Modification Recommended Service Note

N8949A - Autoranging System DC Power Supply, 750V, 40A, 10000W, 400 VAC

Serial Numbers: DE14290000 - DE15369999 without manufacturing ID Version "B"

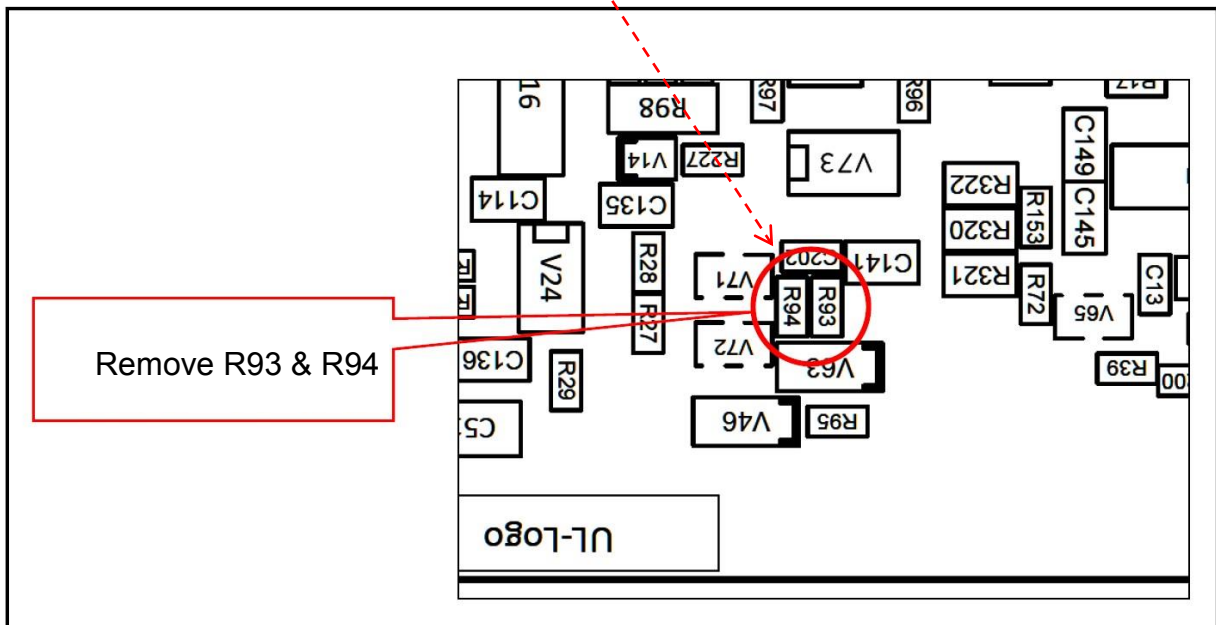
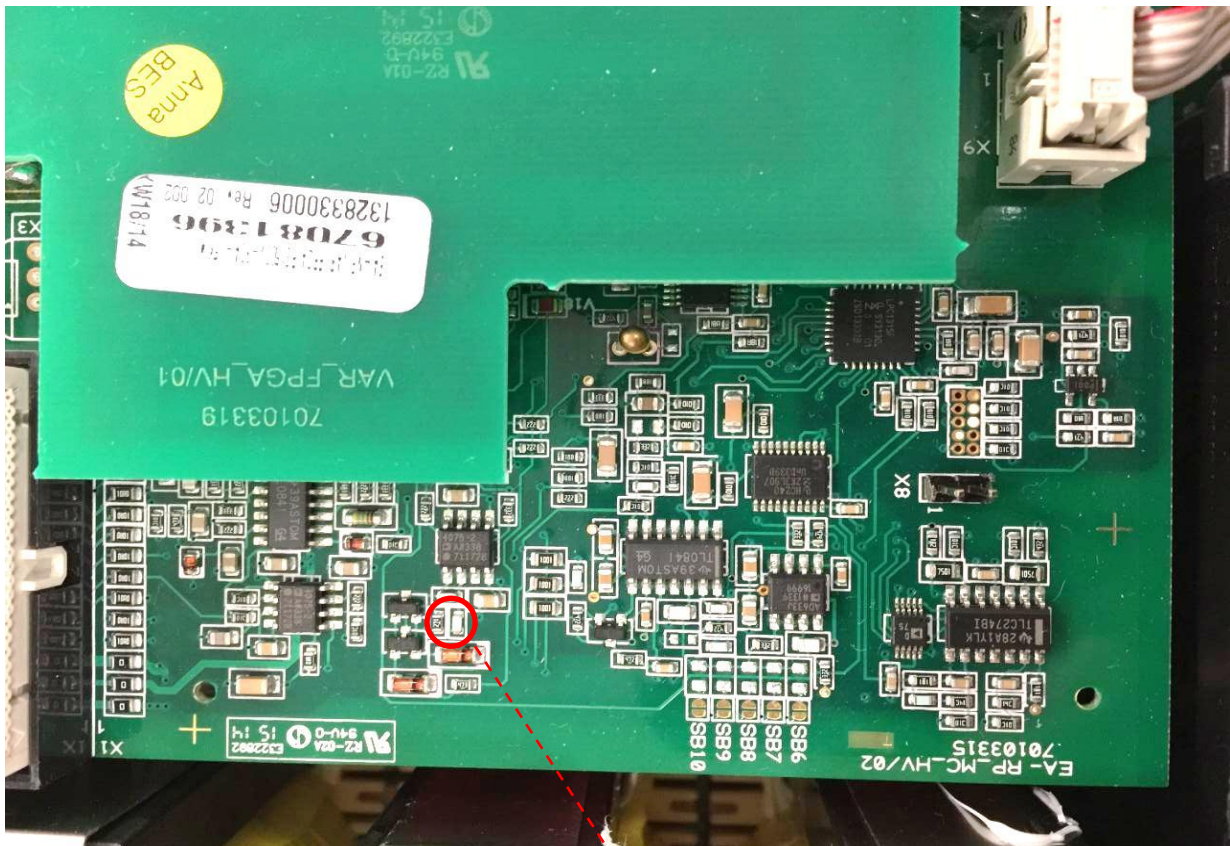
- 1) Remove acMains cable from power source.
- 2) Wait 5 minutes
- 3) Remove top cover from instrument.
- 4) In the 5kW units (viewed from the front of the unit), a small SMT assembly located at the right-rear of instrument will be readily visible (see below):

In the 10kW & 15kW units; although found in the same location, a black plastic cover will have to be removed to gain visibility and access to the SMT assembly. Plastic cover snaps-on and can be removed with a small screwdriver.

Removal of two (2) surface mount resistors, R93 and R94, will correct this problem:

5) SMT resistors R93/94 are located in red circle shown below:

6) After removal of R93 & R94, re-install all covers. Instrument does NOT require recalibration after the removal of R93 & R94.

Suffix “B” added

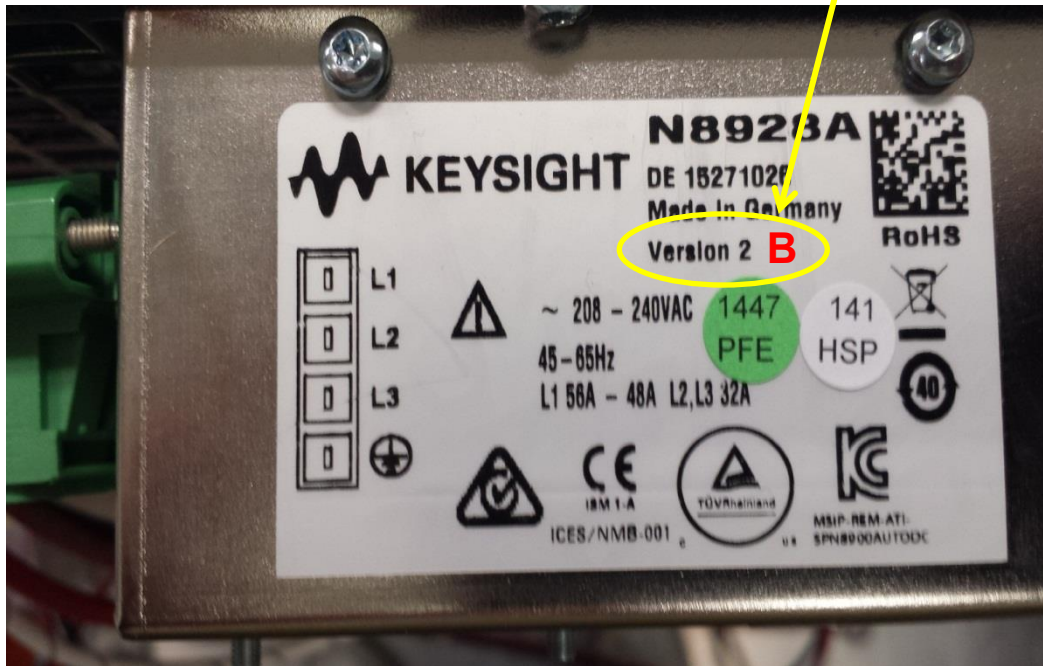
7) On the acMains label, on the rear of the instrument; use an indelible marker, to add the suffix letter “B” after the Version ID. This will assist in the tracking of modified instruments.
